BULLETIN Engine Harness Ground Dealer Inventory Service Action

Reference: PC455 Date: April 14, 2016

SERVICE CAMPAIGN BULLETIN PC455 - 2016 TITAN (A61) - ENGINE HARNESS GROUND TORQUE

Figure 1

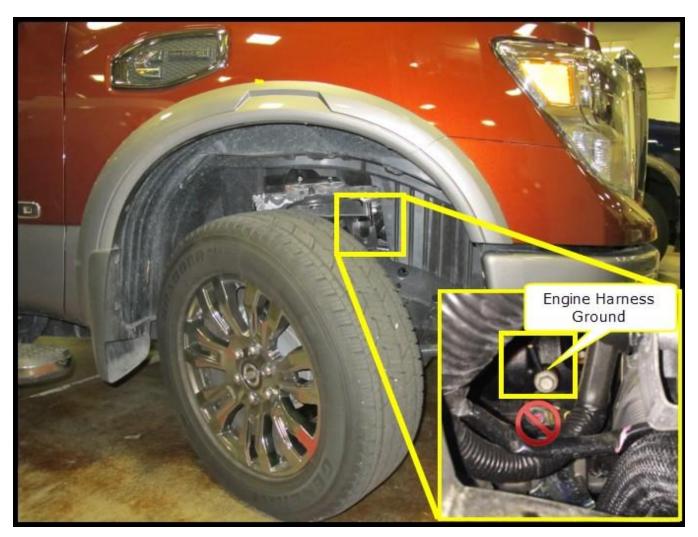
- 1. Park the vehicle in a safe location.
- 2. Turn the steering wheel fully to the right.
- 3. Locate the Engine Harness Ground by looking through the right front wheel well (Figure 1).

NOTE: There are 2 ground wires next to each other. Tighten the **UPPER** bolt for the Engine Harness Ground wire.

- 4. Using a 14 mm socket, a long extension and a torque wrench.
 - Torque the engine harness ground to:
 - 18.0 N·m (**13.0 ft-lb**)
